UTPB - VALET AND DRIVEWAY RENOVATION
6410 Fannin Street/ Houston, Texas 77030

Date: December 16, 2019
Johnston Project No.: 19-00032-00
Prepared by: Paula Gaviria

1. This Addendum addresses architectural, mechanical and electrical revisions as noted below, per comments from EH&S:

SHEET:
A3.01

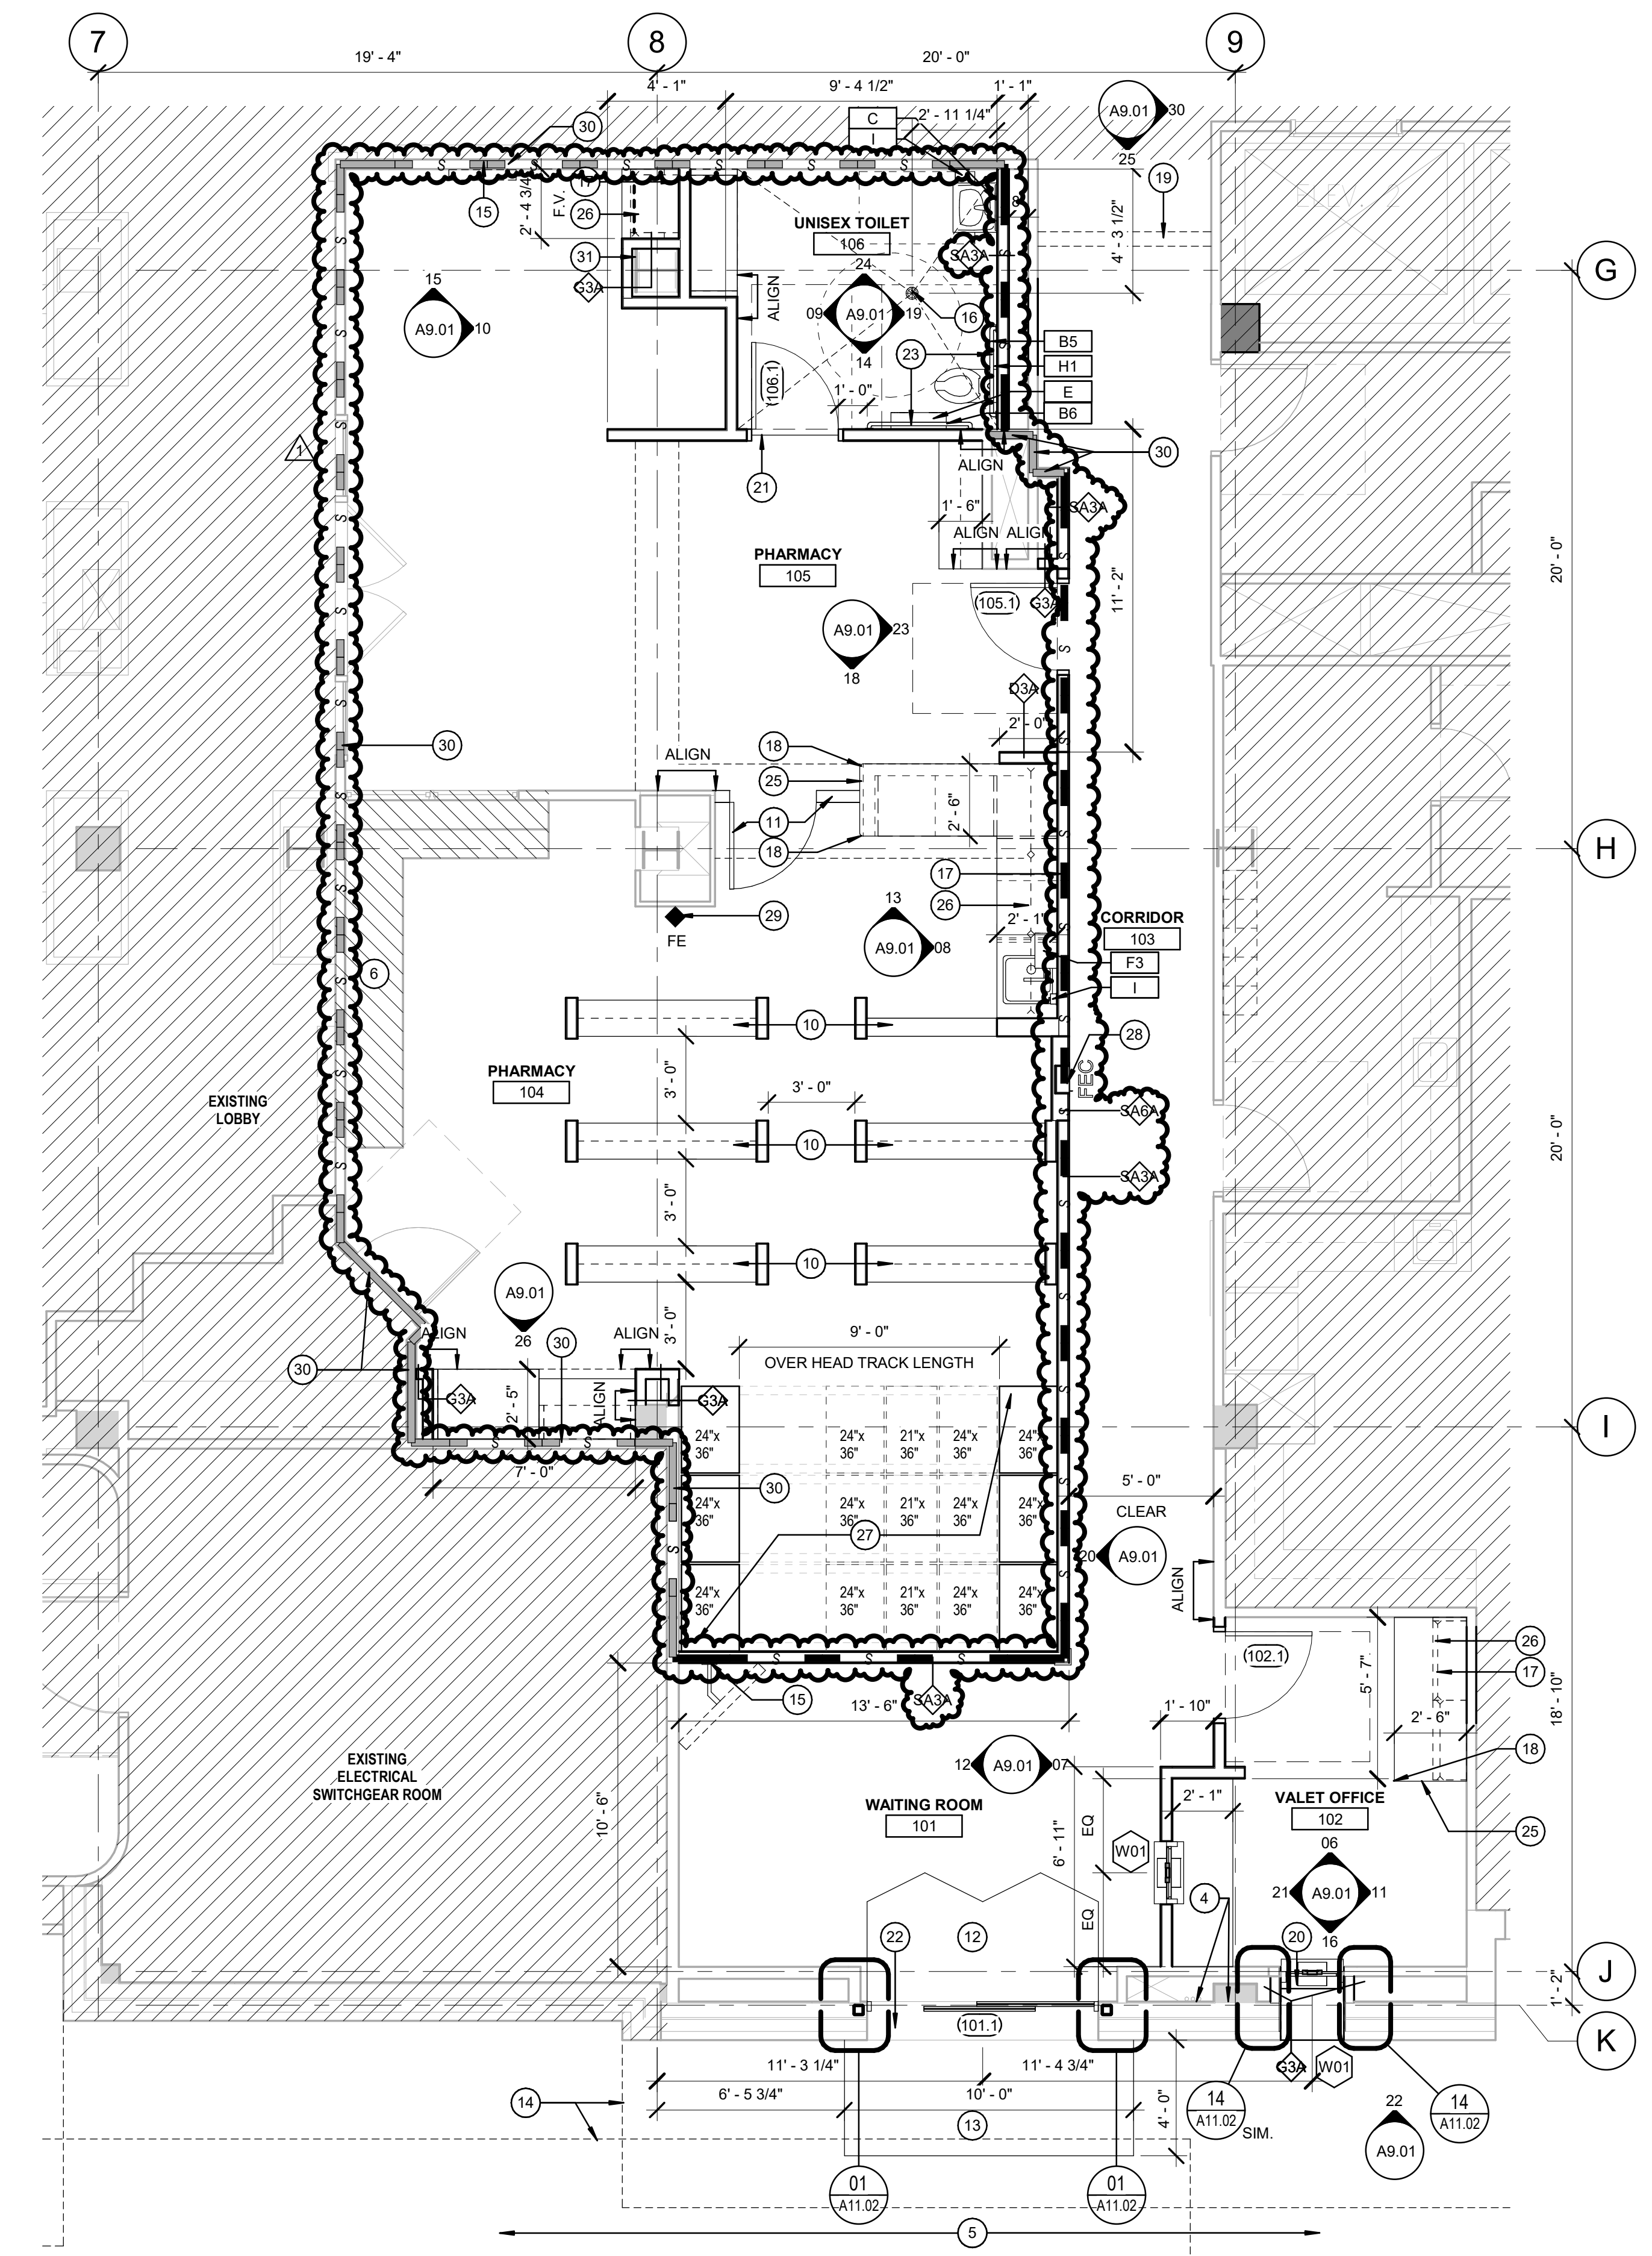
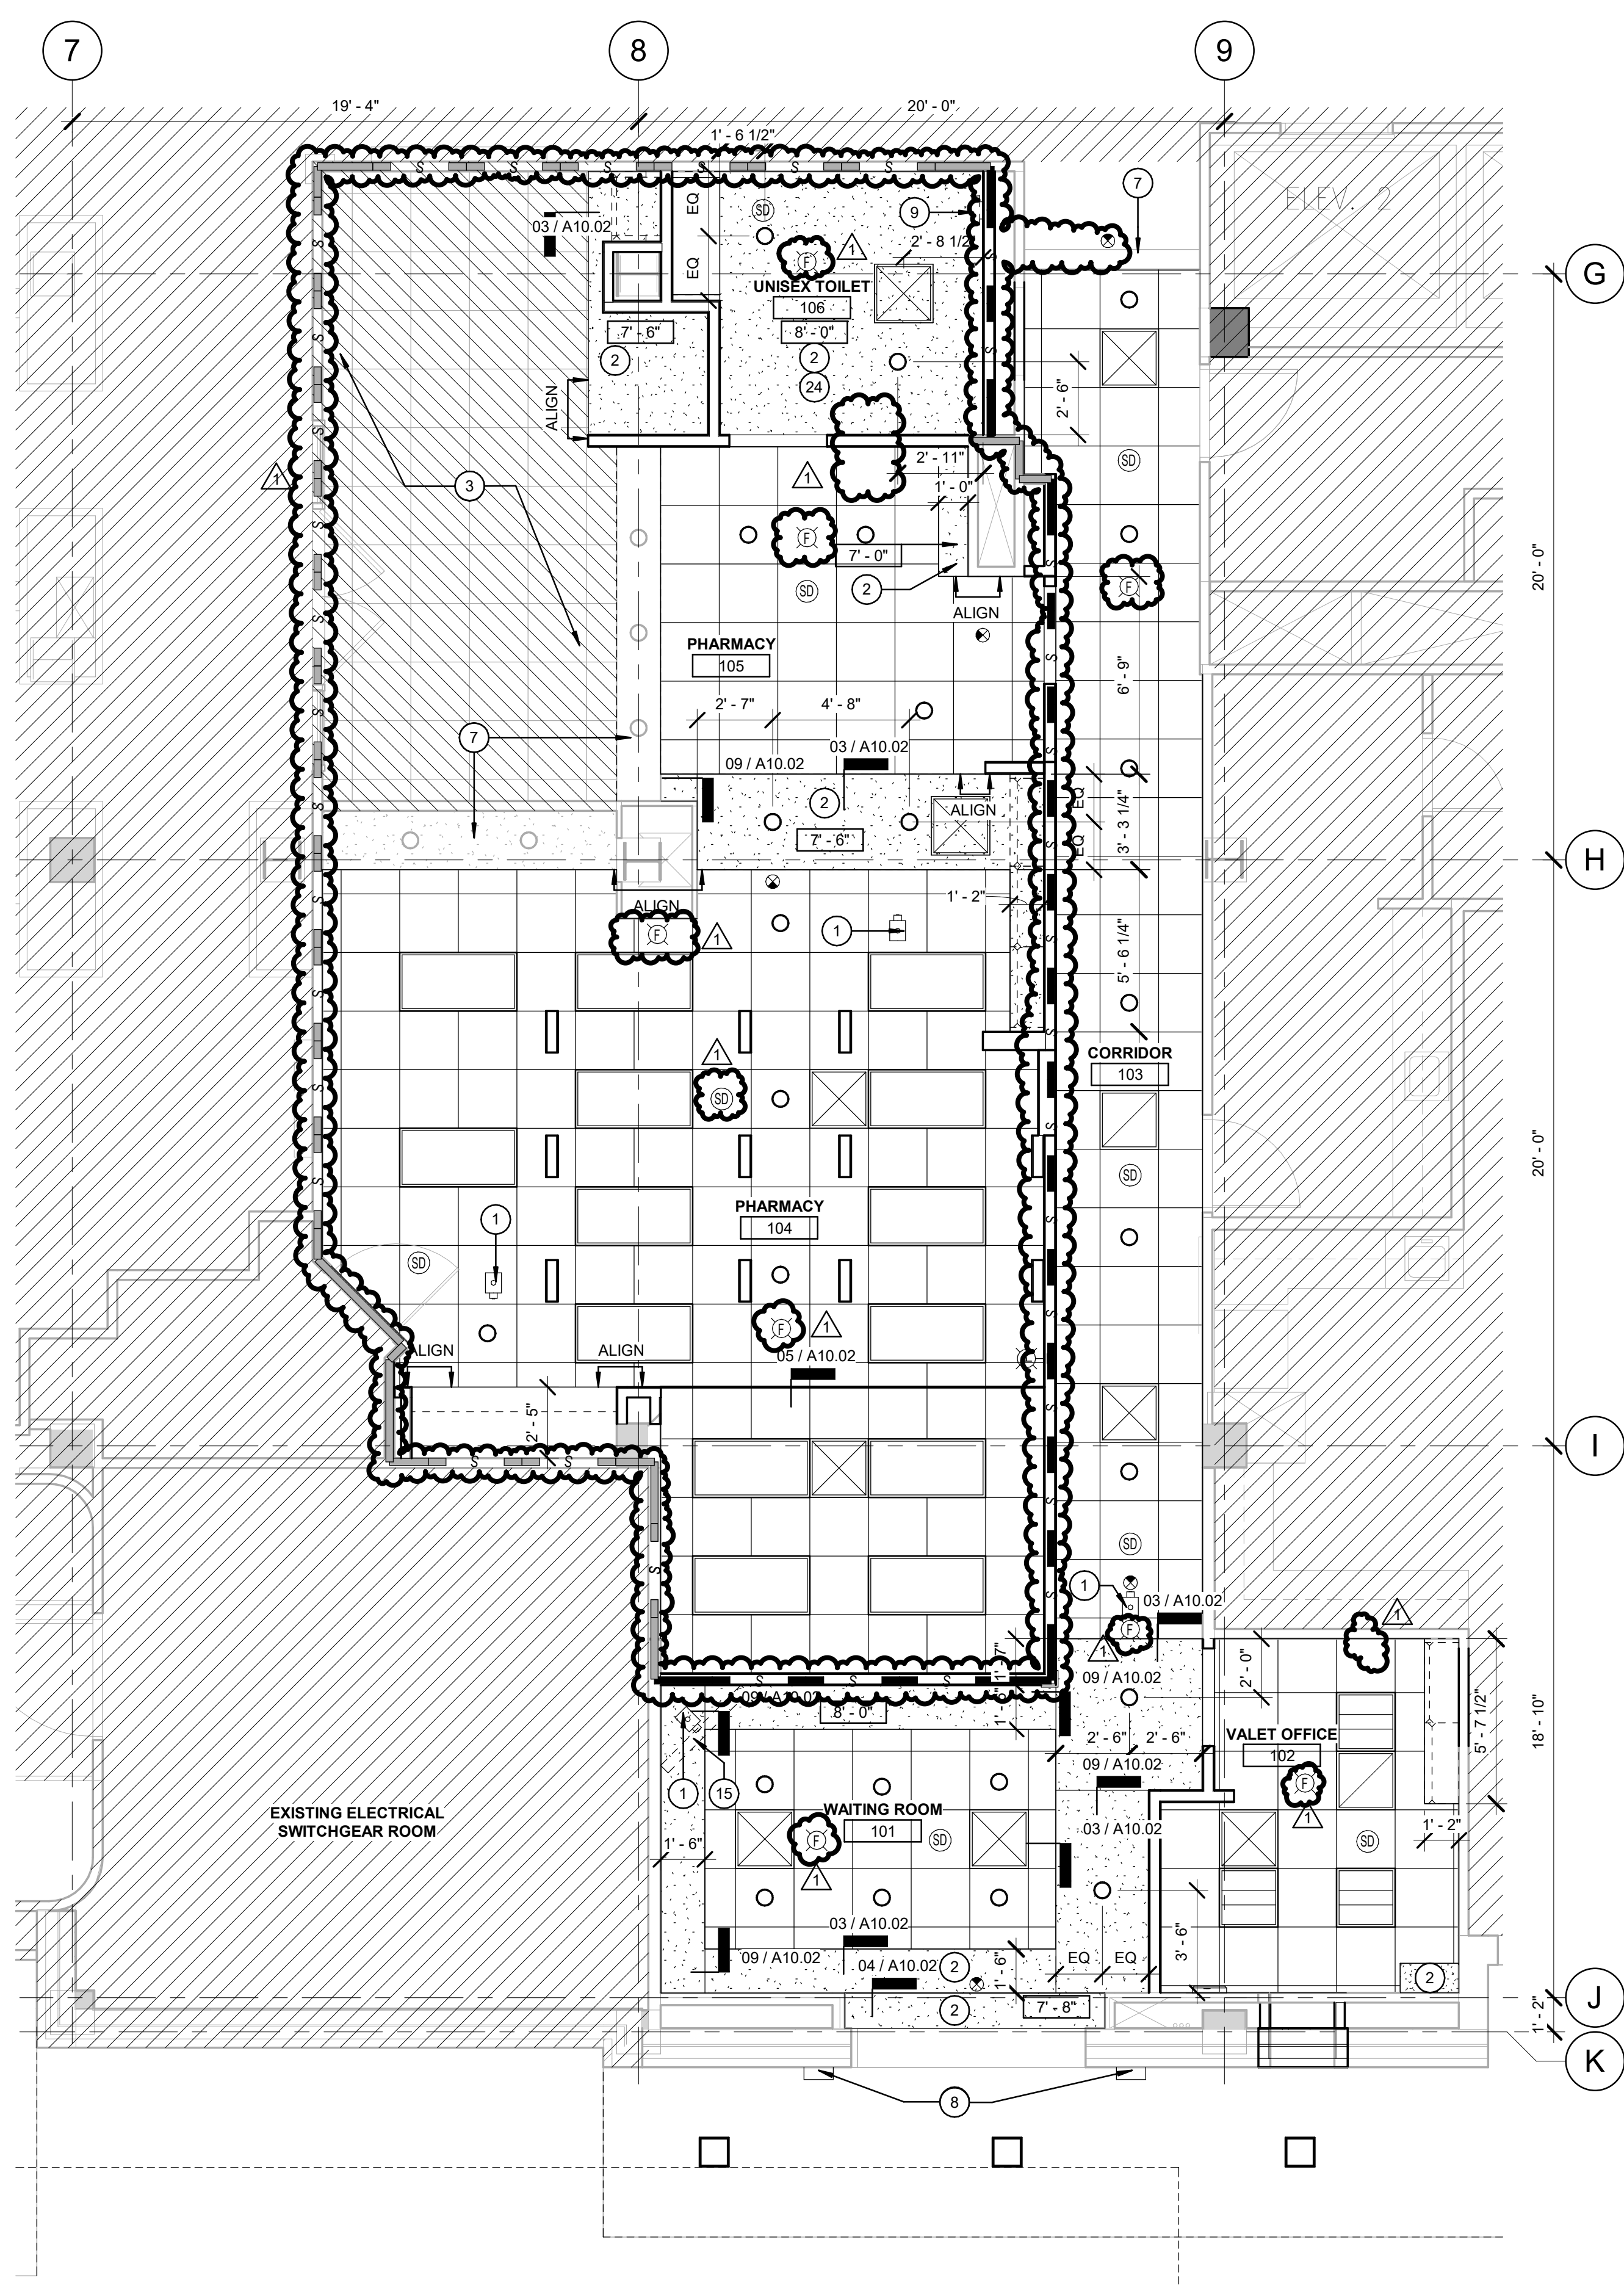
1. A1.01: OVERALL FLOOR PLAN
 - Revised existing and new fire tapes as smoke partitions.
2. A3.01: ENLARGED FLOOR PLAN & REFLECTED CEILING PLAN – INTERIOR
 - Revised existing and new fire tapes as smoke partitions.
 - Revised wall types to be smoke partitions.
 - Added exit sign to Corridor 103.
 - Added Fire Rated Legend to sheet.
 - Added a smoke detector in Pharmacy
 - Added and relocated fire strobes.
3. A10.04: PARTITION TYPES
 - Added wall type SA to sheet.
 - Removed wall type 1A from sheet.
4. A11.01: OPENING SCHEDULE
 - Revised door 105.1 and 106.1 fire rating.

SMOKE DAMPER 07

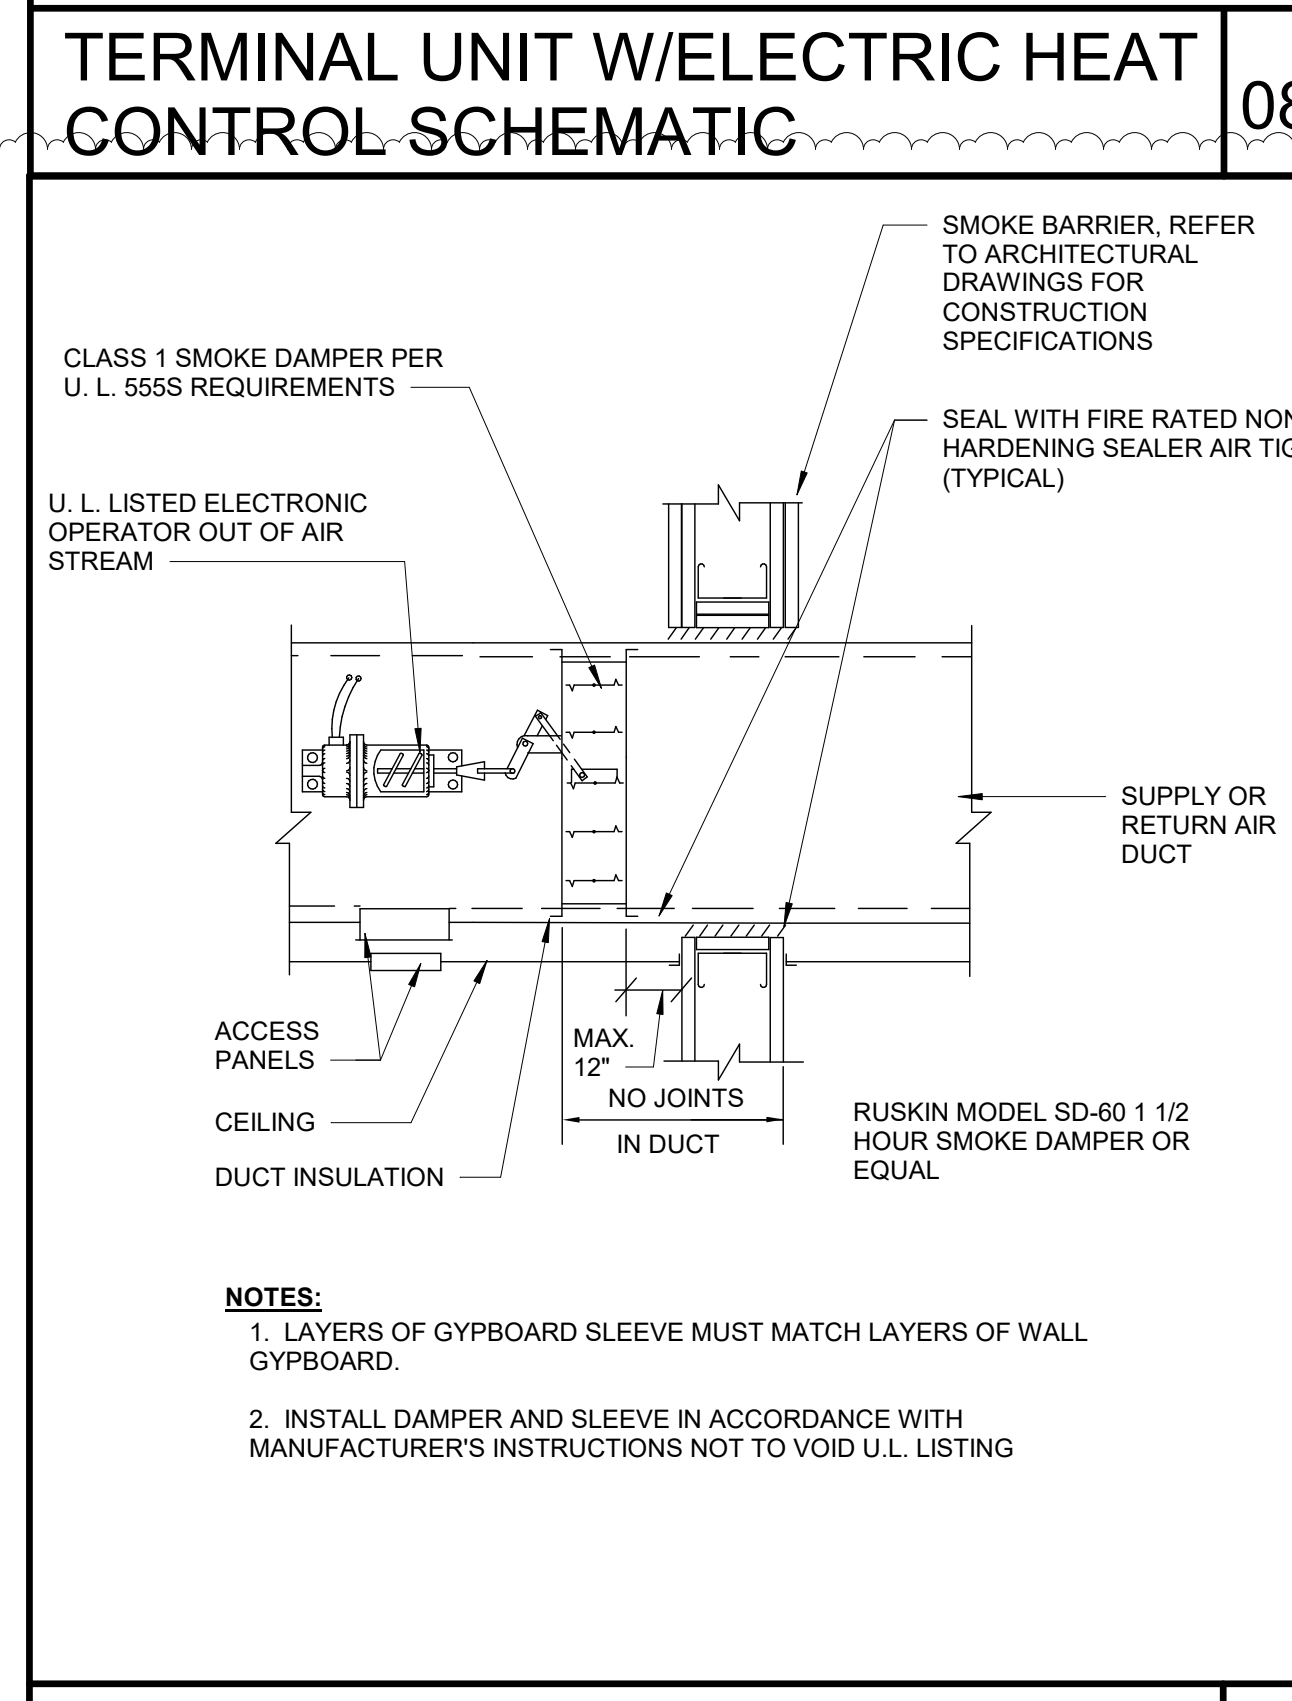
1. M0.01: MECHANICAL SCHEDULES, CONTROLS, AND DETAILS
 - Replaced detail for smoke dampers.
2. M2.01: MECHANICAL DUCTWORK PLAN – LEVEL 1
 - Revised keynote number 12 referring to smoke damper installation.
